**NEW YORK STATE THRUWAY AUTHORITY
DEPARTMENT OF ENGINEERING**

**AMENDMENT NO. 2
TO**

**CONTRACT TAN 26-14
D215082
PAVEMENT REHABILITATION AND MISCELLANEOUS
WORK ON I-190, NIAGARA THRUWAY
FROM MP N0.7 TO MP N4.2
IN THE BUFFALO DIVISION
OF THE NEW YORK STATE THRUWAY
IN ERIE COUNTY**

**IN THE LETTING OF
FEBRUARY 25, 2026**

TITLE OF PROJECT I-190 HIGHWAY REHABILITATION	CONTRACT NUMBER: TAN 26-14
	LOCATION OF PROJECT I-190 NIAGARA THRUWAY MP 900.7 TO MP 904.2	DATE: FEB. 2026
	TITLE OF DRAWING WZTC NORTHBOUND SECTION 2/ PHASE 2/ STAGE 1	DRAWING NUMBER: TCP-44

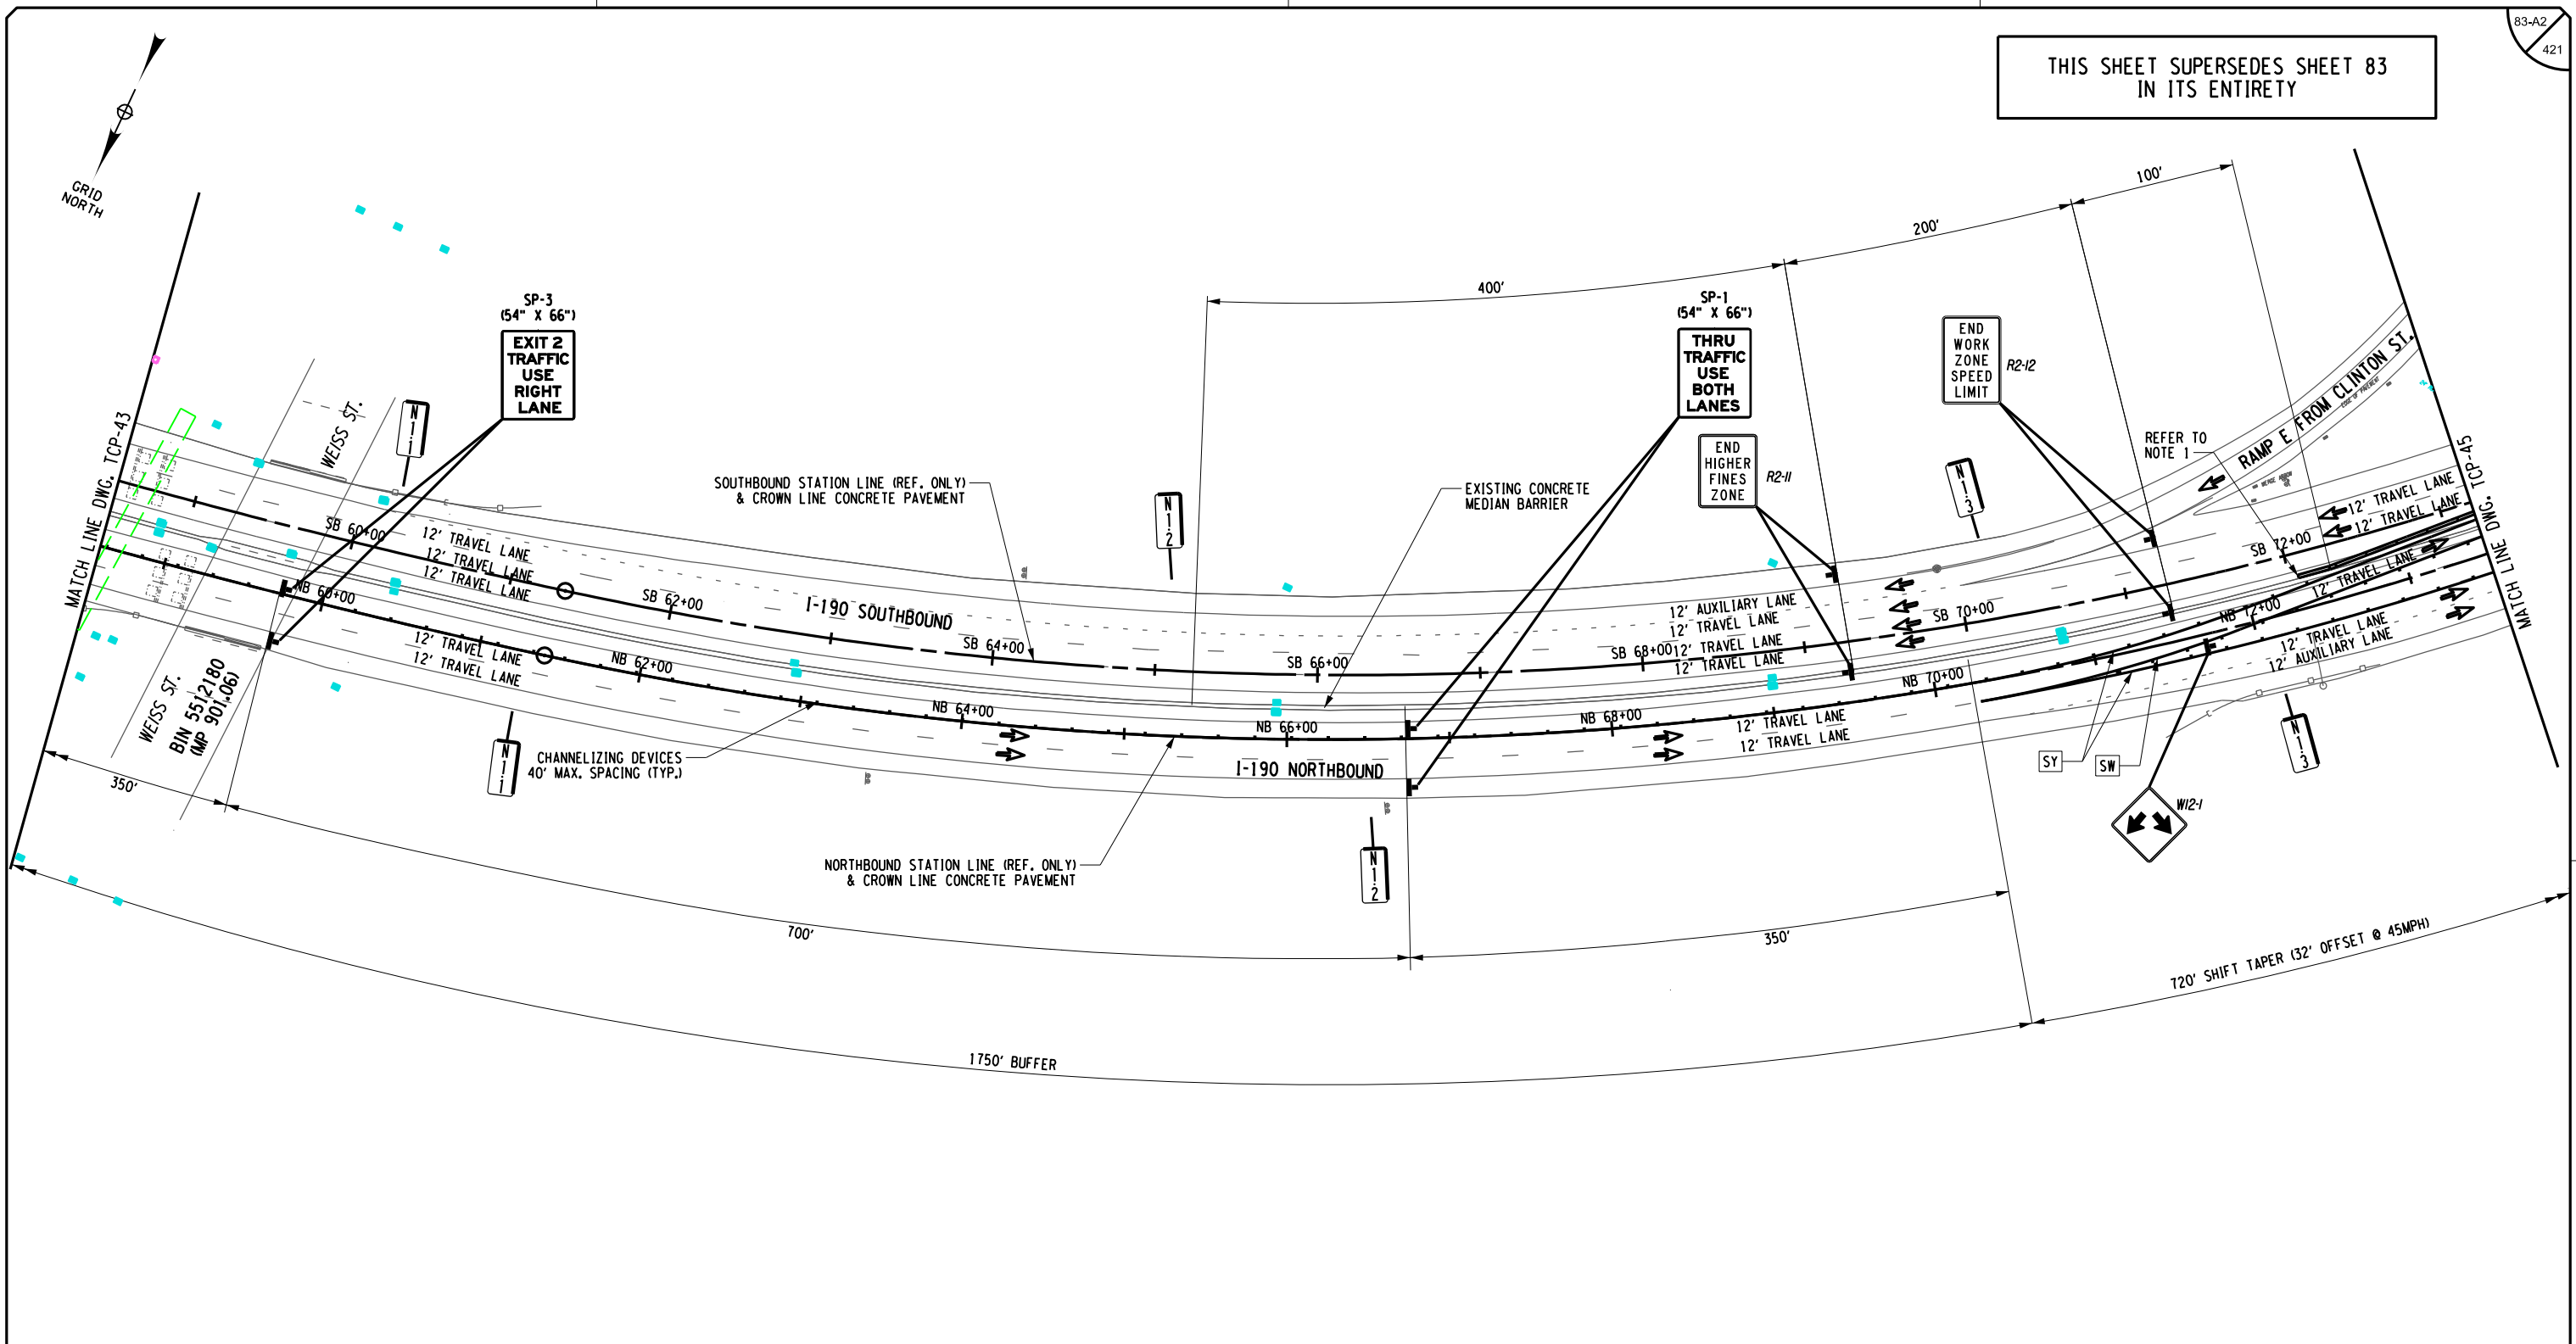
6. **DELETE** Drawing Number TCP-44, Sheet 83 of 421, and **SUBSTITUTE** with the attached Drawing Number TCP-44, Sheet 83-A2 of 421. “SP-1” signs were changed to fit field conditions, and the size of SP-1 sign was added to the sheet.

TITLE OF PROJECT I-190 HIGHWAY REHABILITATION	CONTRACT NUMBER: TAN 26-14
LOCATION OF PROJECT I-190 NIAGARA THRUWAY MP 900.7 TO MP 904.2	DATE: FEB. 2026
TITLE OF DRAWING WZTC NORTHBOUND SECTION 2/ PHASE 2/ STAGE 2	DRAWING NUMBER: TCP-51

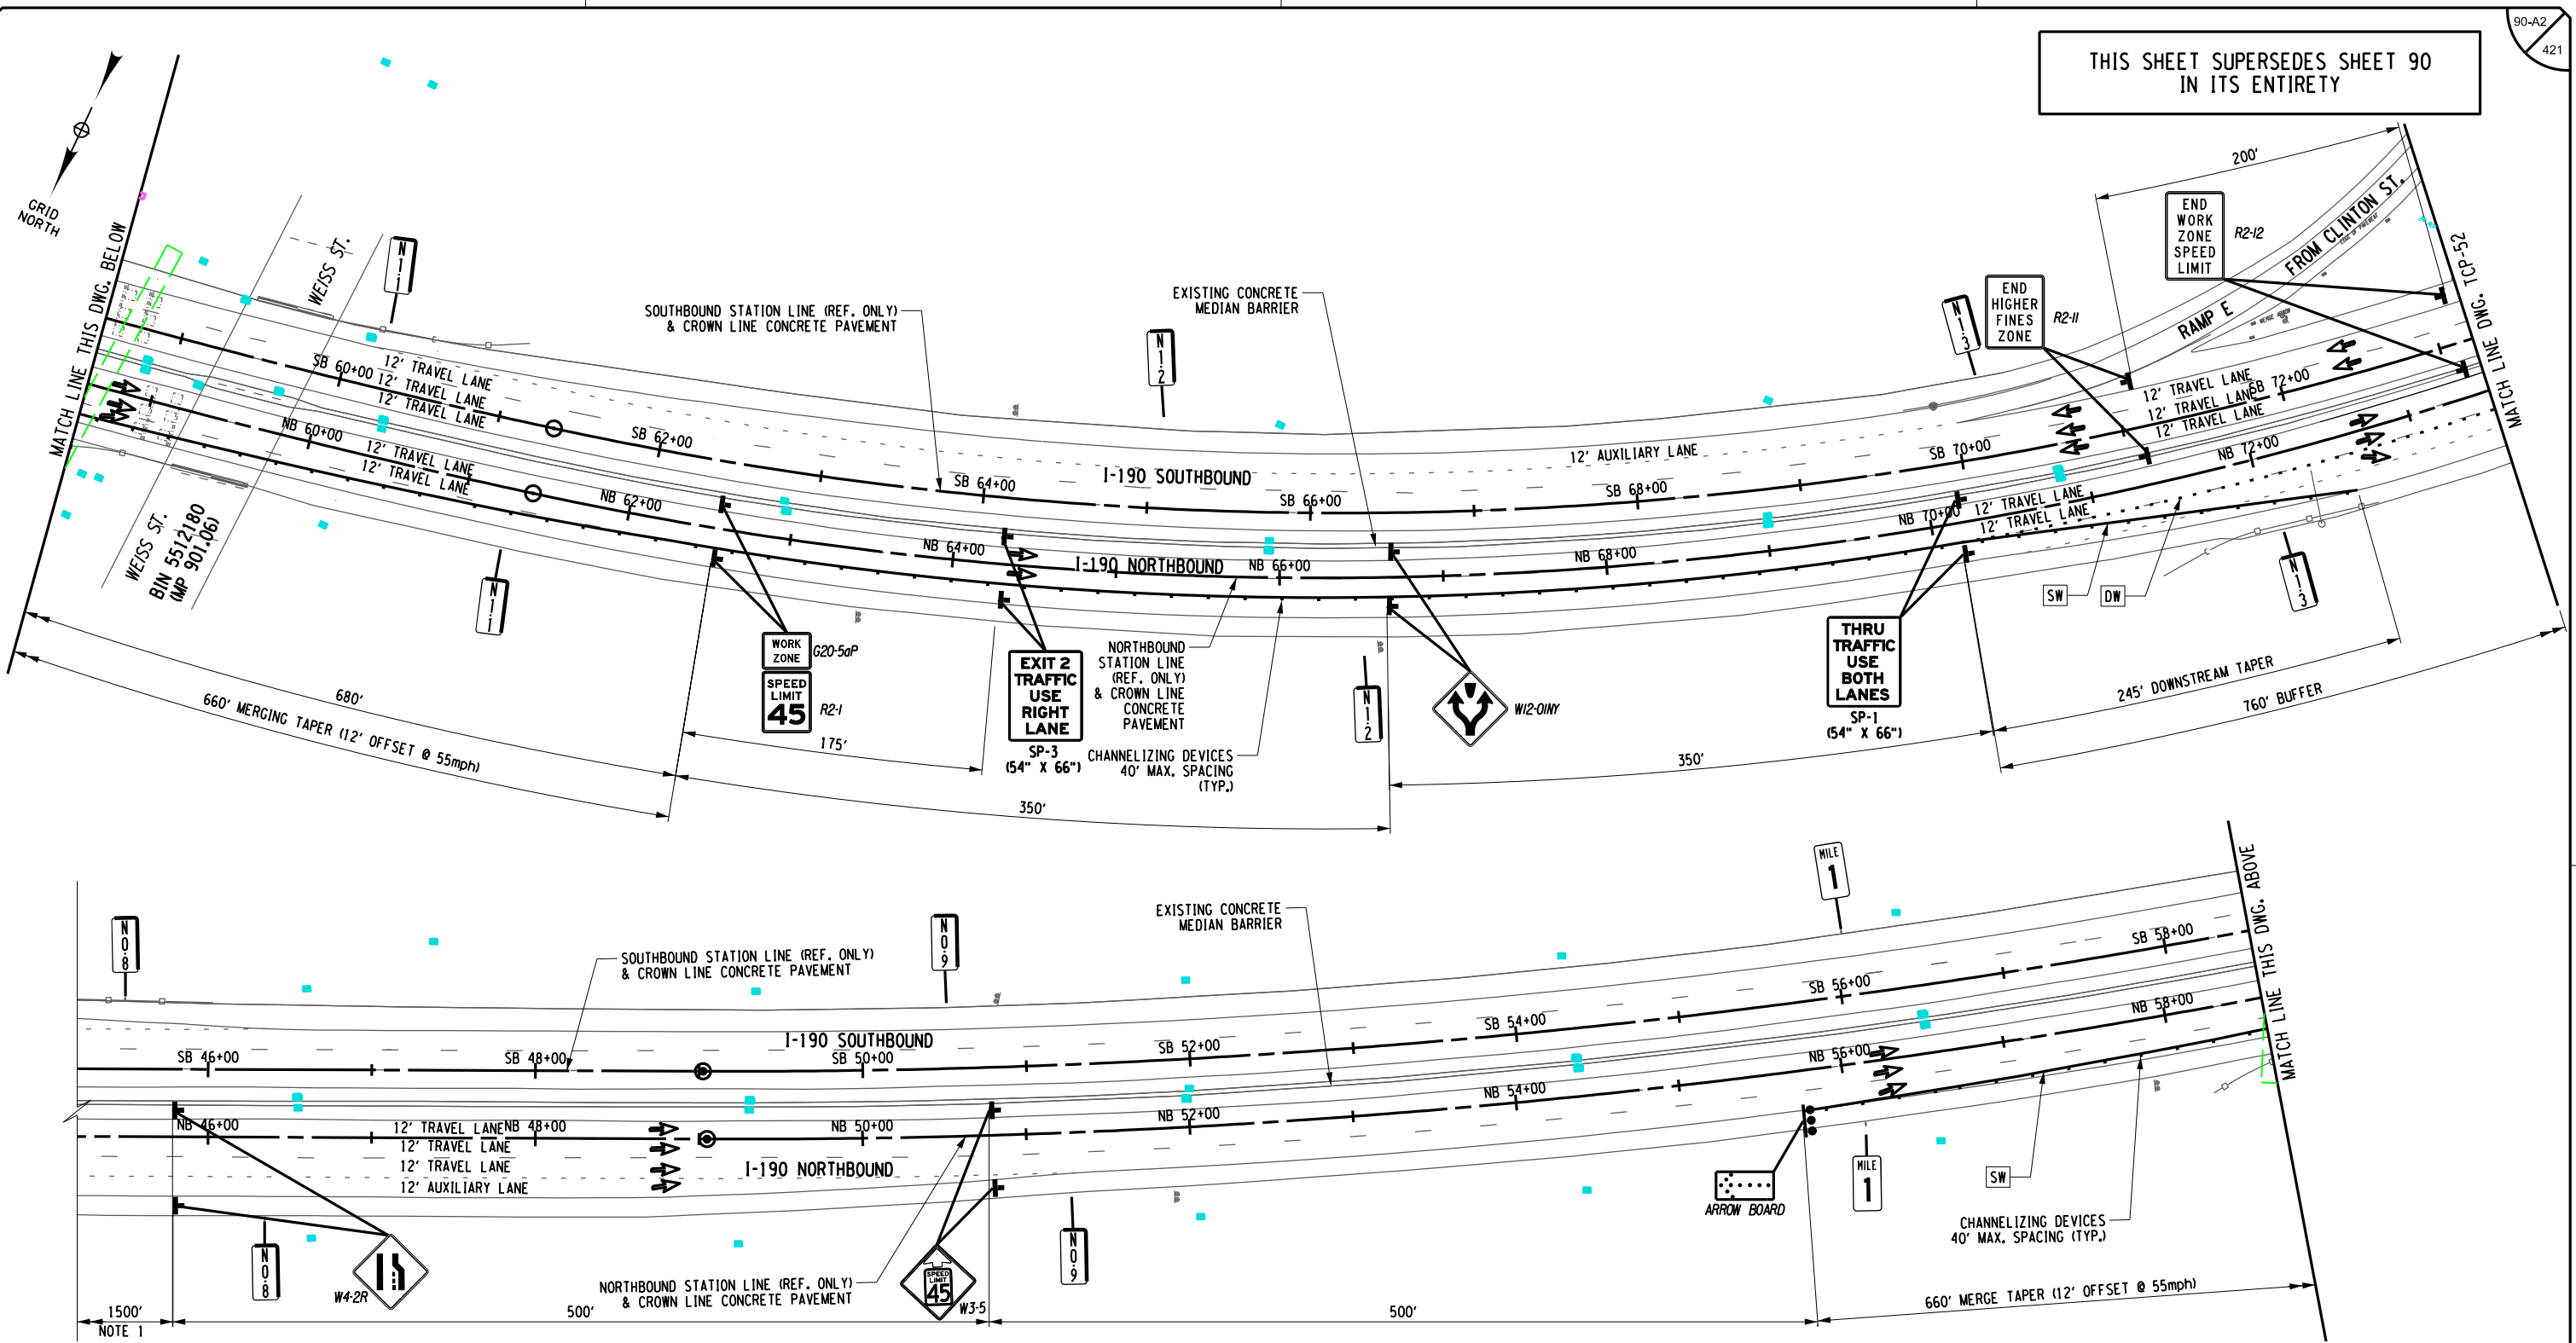
7. **DELETE** Drawing Number TCP-51, Sheet 90 of 421, and **SUBSTITUTE** with the attached Drawing Number TCP-51, Sheet 90-A2 of 421. “SP-1” and “SP-3” signs were changed to fit field conditions, and the sizes of SP-1 and SP-3 signs were added to the sheet.

TITLE OF PROJECT I-190 HIGHWAY REHABILITATION	CONTRACT NUMBER: TAN 26-14
LOCATION OF PROJECT I-190 NIAGARA THRUWAY MP 900.7 TO MP 904.2	DATE: FEB. 2026
TITLE OF DRAWING WZTC SOUTHBOUND SECTION 3/ PHASE 1/ STAGE 1	DRAWING NUMBER: TCP-63

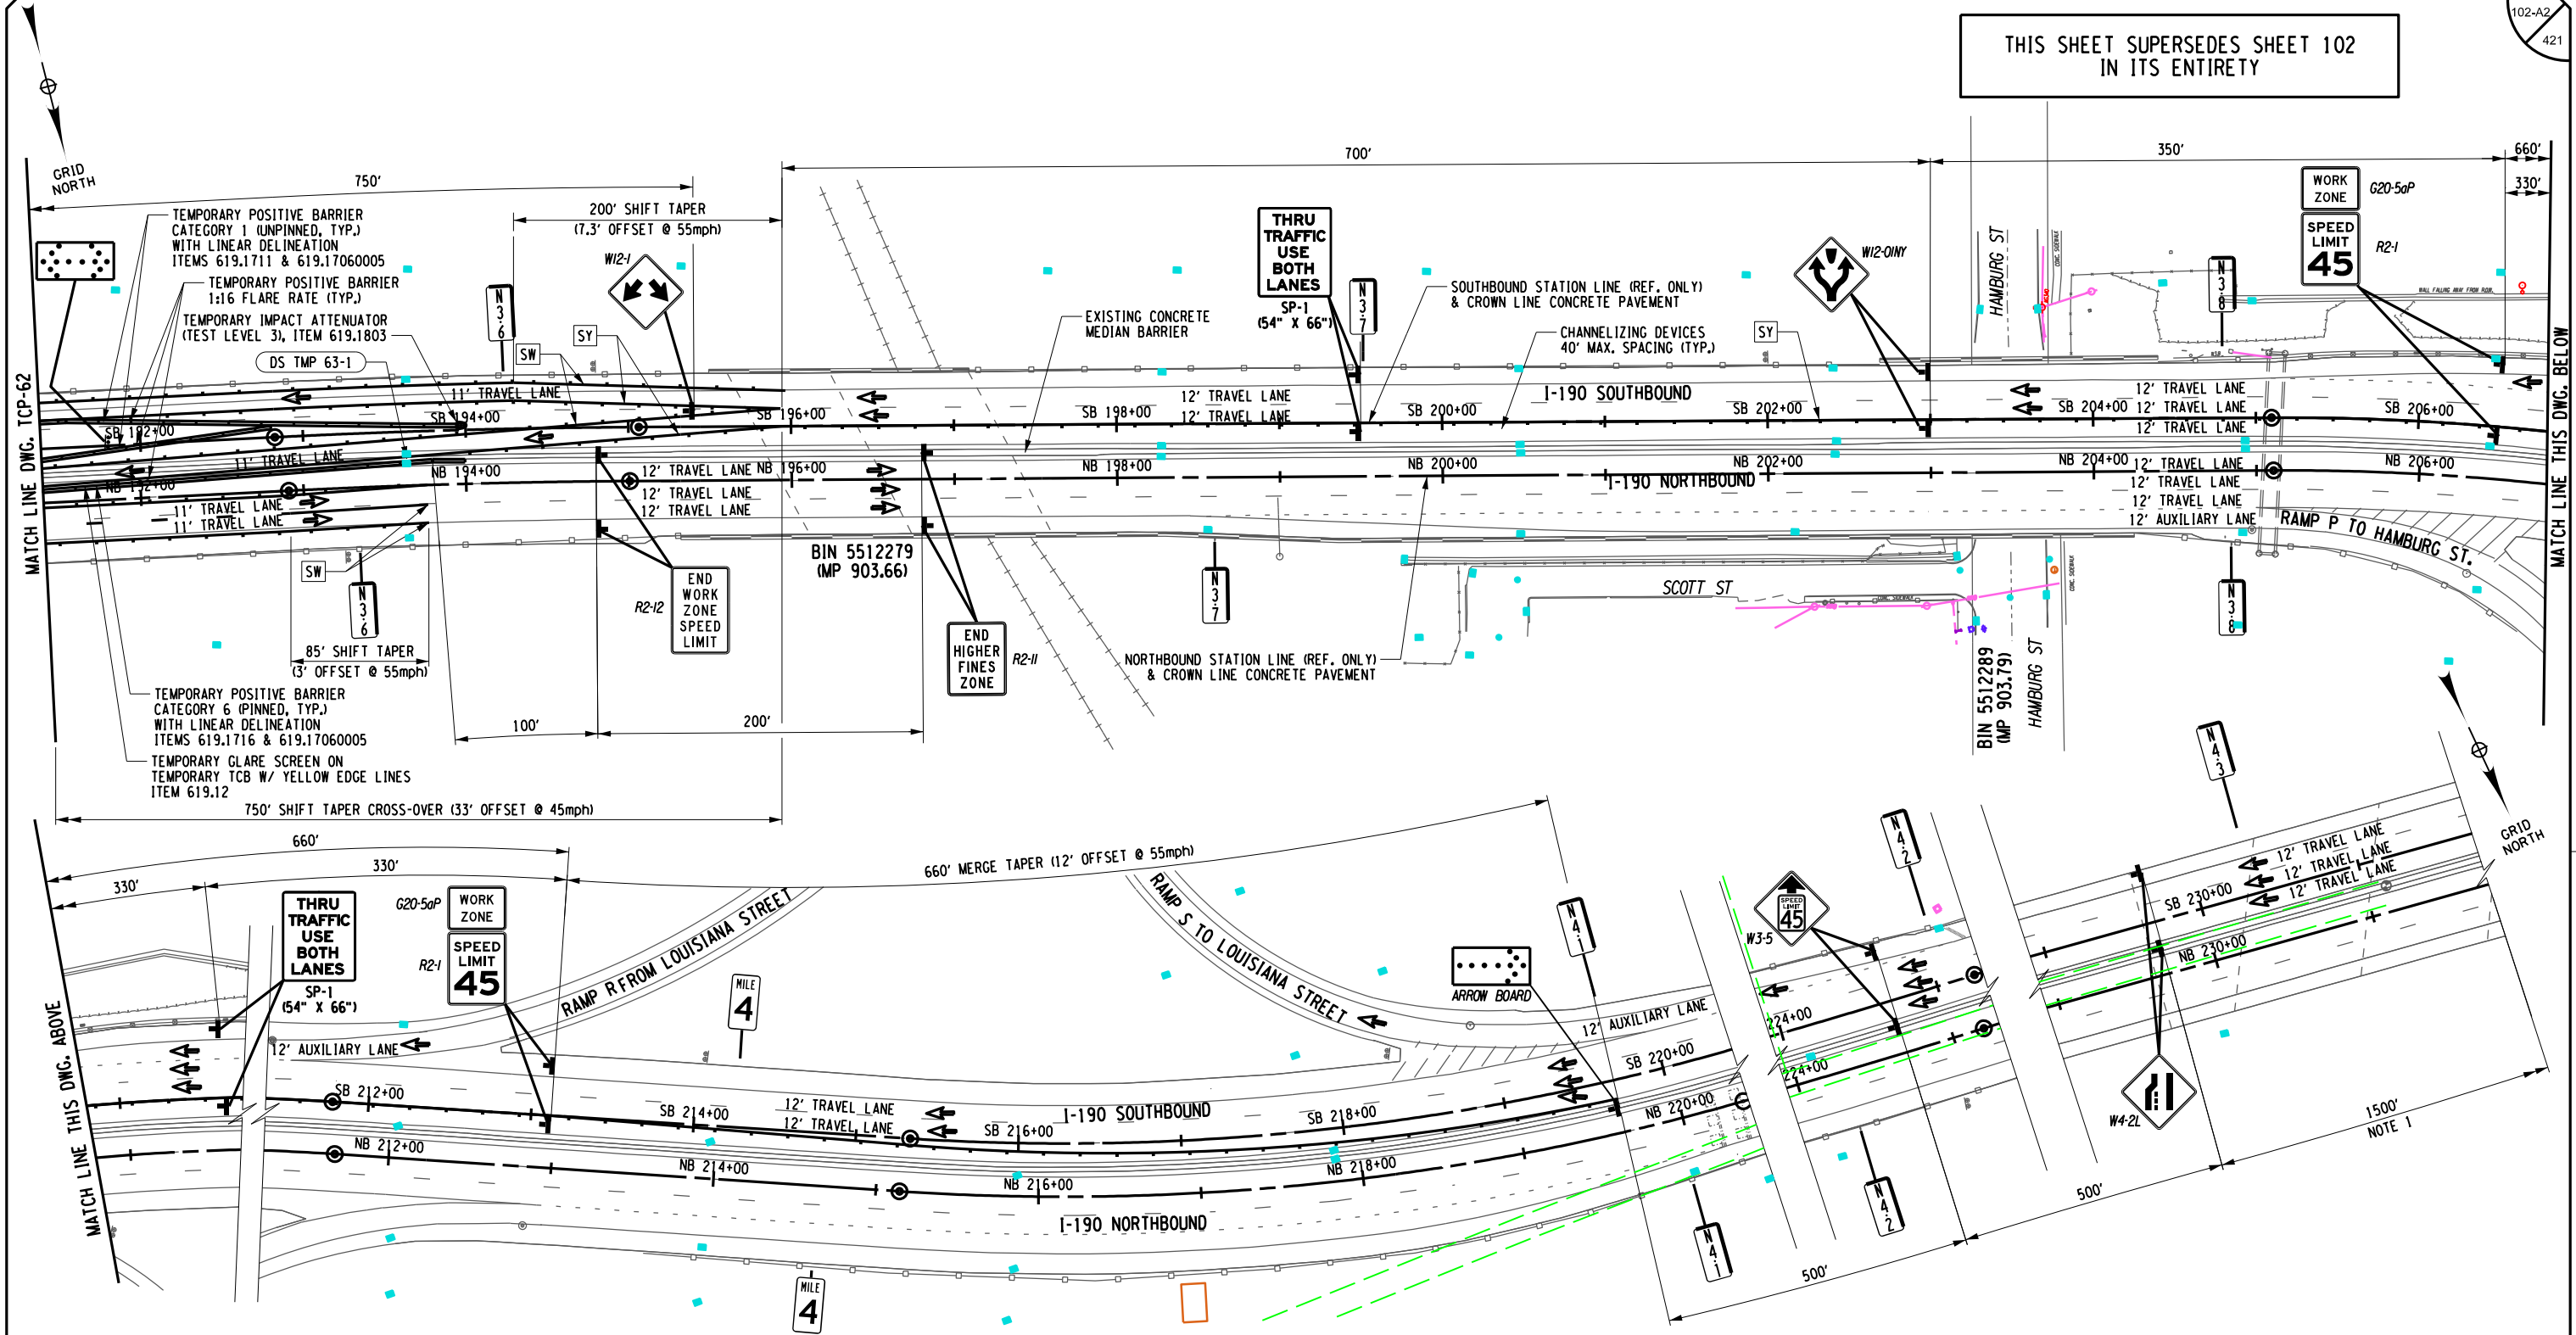
8. **DELETE** Drawing Number TCP-63, Sheet 102 of 421, and **SUBSTITUTE** with the attached Drawing Number TCP-63, Sheet 102-A2 of 421. “SP-1” signs were changed to fit field conditions, and the size of SP-1 sign was added to the sheet.
